## HISTORIC AND DESIGN REVIEW COMMISSION

June 17, 2020

**HDRC CASE NO:** 2020-240  
**ADDRESS:** 602 E CARSON  
**LEGAL DESCRIPTION:** NCB 1264 BLK 3 LOT E 55.8 OF N 134.15 OF 2 OR 2B  
**ZONING:** R-6, H  
**CITY COUNCIL DIST.:** 2  
**DISTRICT:** Government Hill Historic District  
**APPLICANT:** Linda Lira/LIRA LINDA  
**OWNER:** Linda Lira/LIRA LINDA  
**TYPE OF WORK:** Fence replacement with new driveway gate  
**APPLICATION RECEIVED:** May 19, 2020  
**60-DAY REVIEW:** Not applicable due to City Council Emergency Orders  
**CASE MANAGER:** Huy Pham  
**REQUEST:**

1. Repair/replace the existing front yard fence;
2. Re-install a missing pedestrian gate at the front fence;
3. Install a chain-link sliding driveway gate

- 48" picket Fence
- 6' privacy Fence
- CHAIN LINK Fence
- Replacement Gate + sliding Driveway Gate

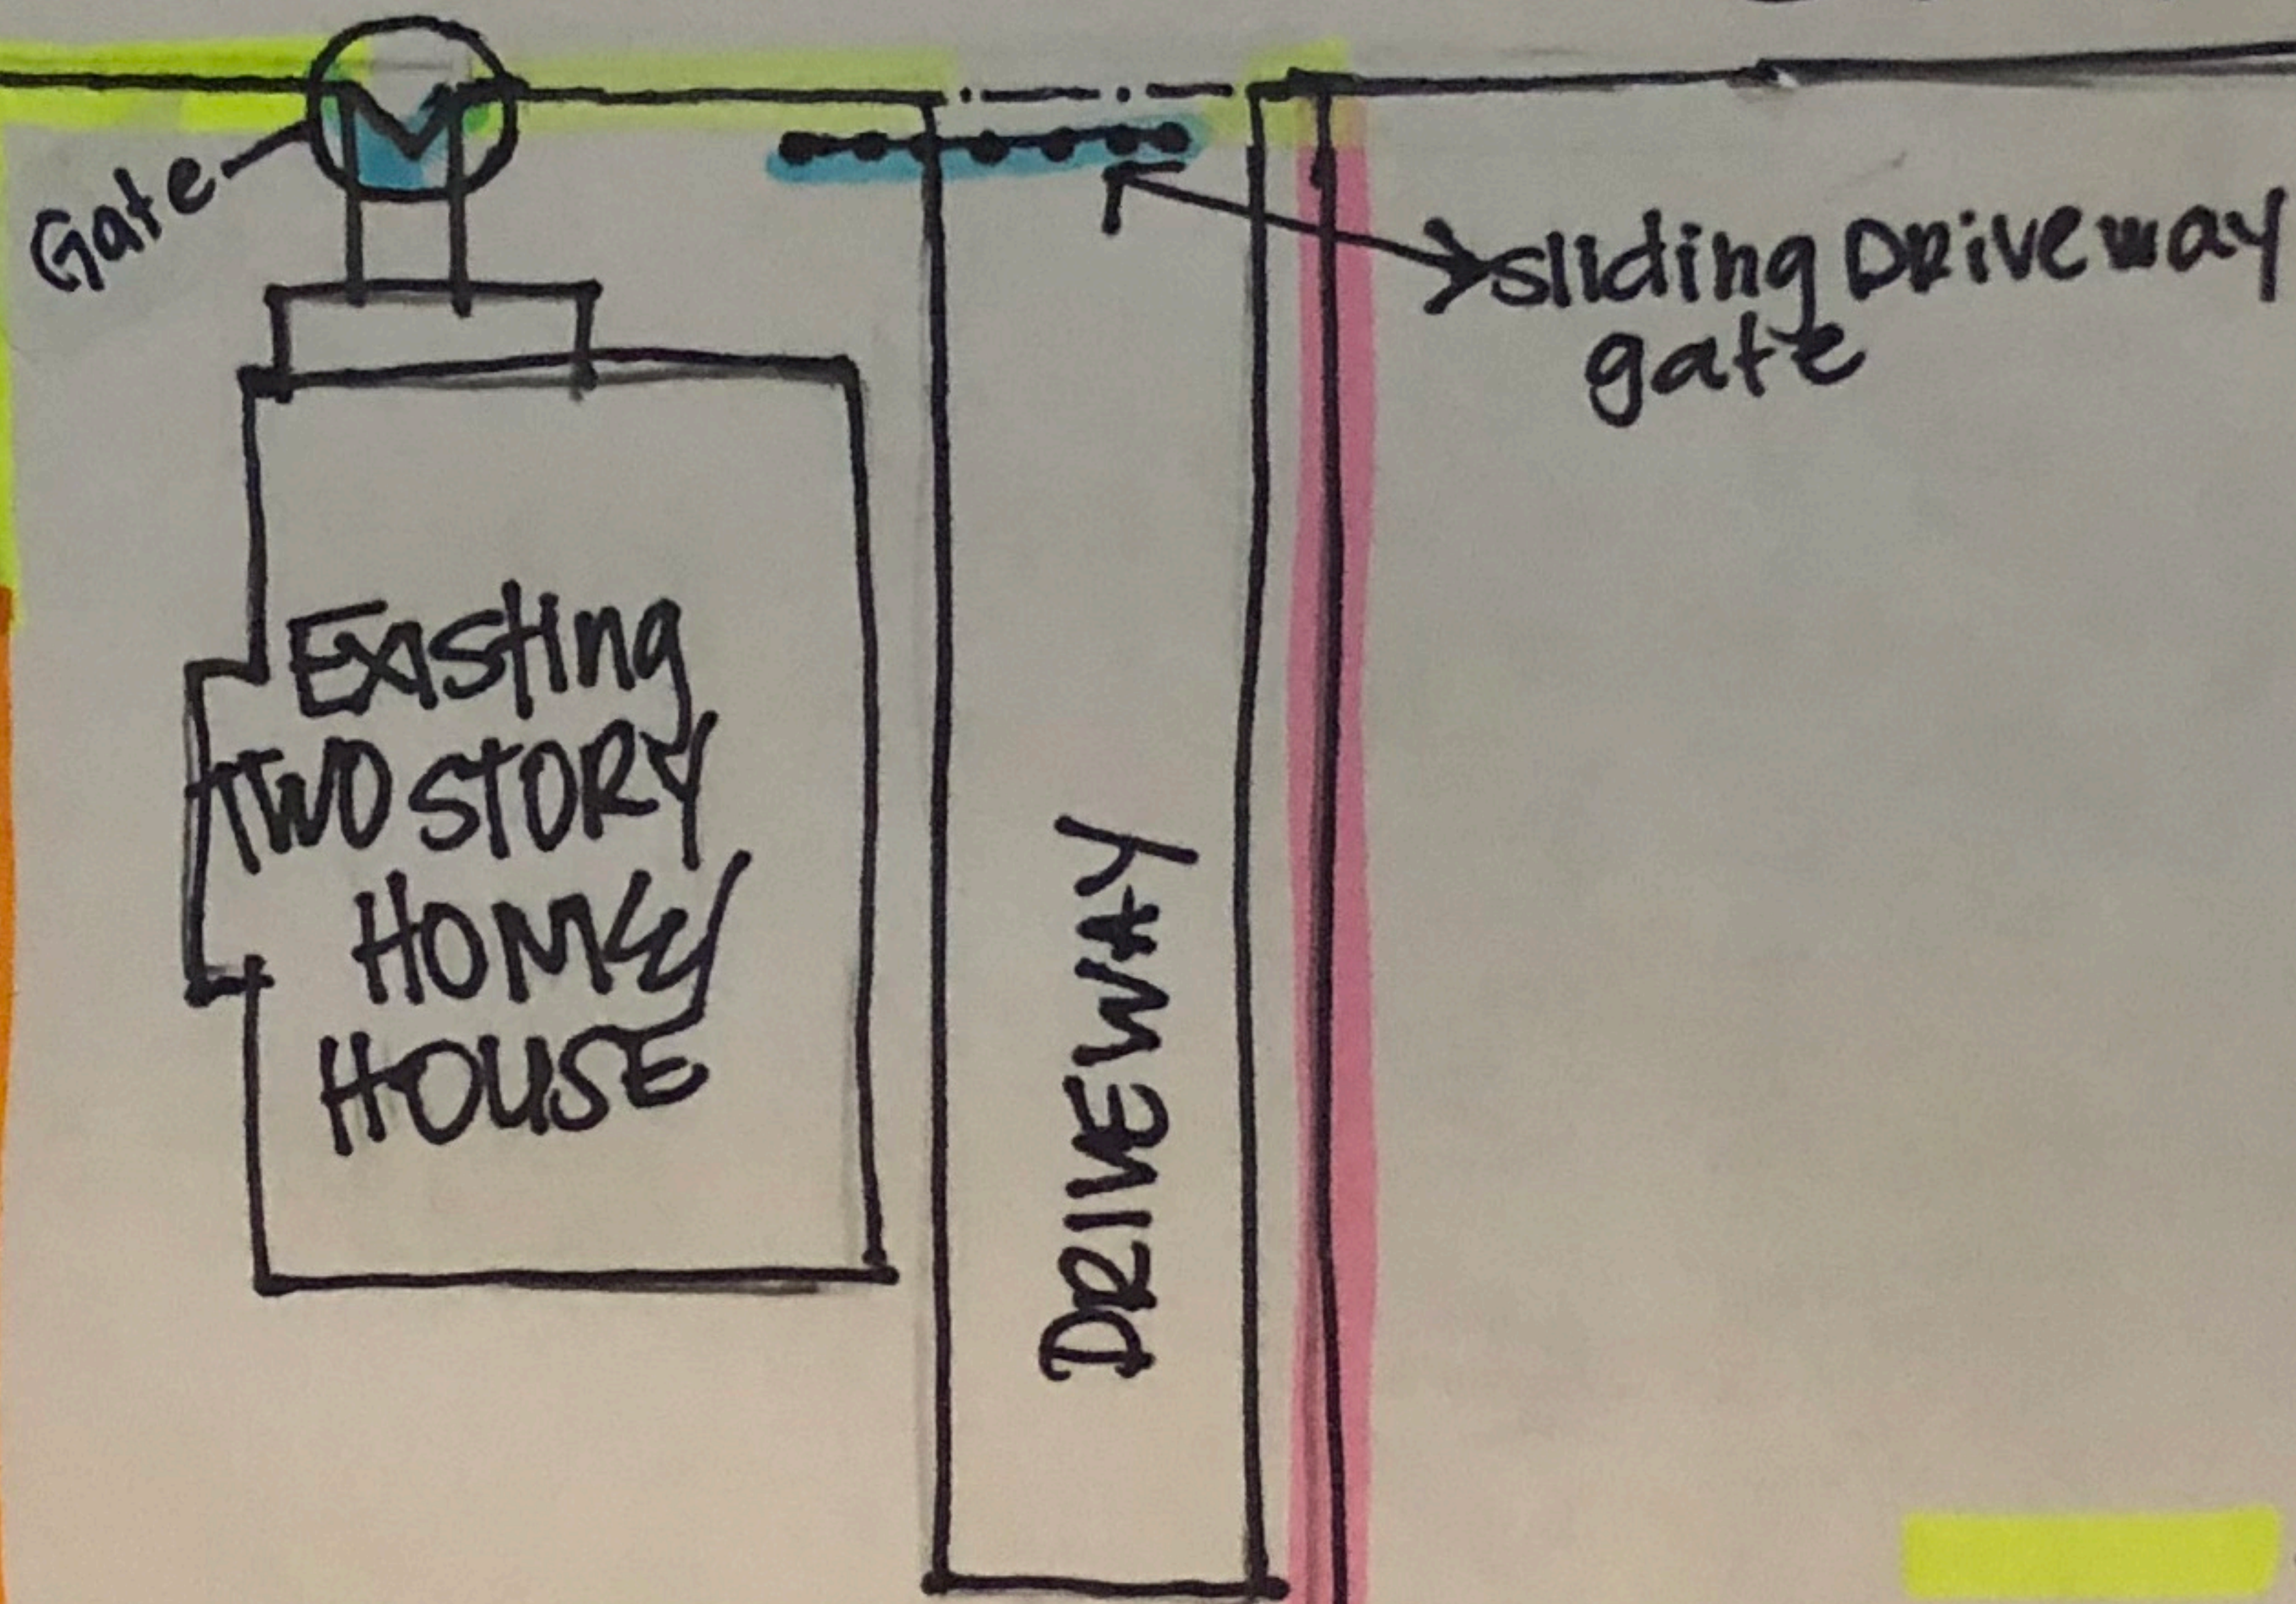
- b. FENCE REPAIR – The applicant has proposed to repair the existing wood picket fence and replace fully deteriorated or missing elements, including the installation of a pedestrian gate. Per the Guidelines for Site Elements 2.B.v., applicants should install new fences or walls of materials similar to fence materials historically used in the district. Materials that are similar in scale, texture, color, and form as those historically used in the district, and that are compatible with the main structure should be used. Staff finds that the existing 4' tall wood picket fence is consistent with those found historically in the district and style of the house and may be repaired in-place with matching materials.

- c. DRIVEWAY GATE – The applicant has proposed to install a sliding driveway gate featuring a 20' width and chain-link, at the front of the driveway. Per the Guidelines for Site Elements 2.B.iv., chain-link fencing is a prohibited material. Per the Guidelines for Site Elements 5.B.i., historic driveways are typically no wider than 10 feet. Staff finds that the proposed driveway gate is inappropriate in location, width, and design. The front yard fence should instead turn at the driveway to meet the corner of the house, the driveway gate is set behind the front yard plane of the house, and features an appropriate wood design; fences and gates set behind the front of the house may feature a maximum height of 6 feet.

Staff recommends approval of in-kind wood fence repair and pedestrian gate installation based on finding b.

Staff does not recommend approval of the driveway gate as proposed based on finding c. Staff recommends the following:

- i. That the front yard fence turn at the driveway to meet the corner of the house rather than span the driveway at the right of way.
- ii. That the driveway gate be set behind the front façade of the house.
- iii. That the proposed fence feature a design that is consistent with the Guidelines.
- iv. That the rear privacy fence not exceed six (6) feet in height.
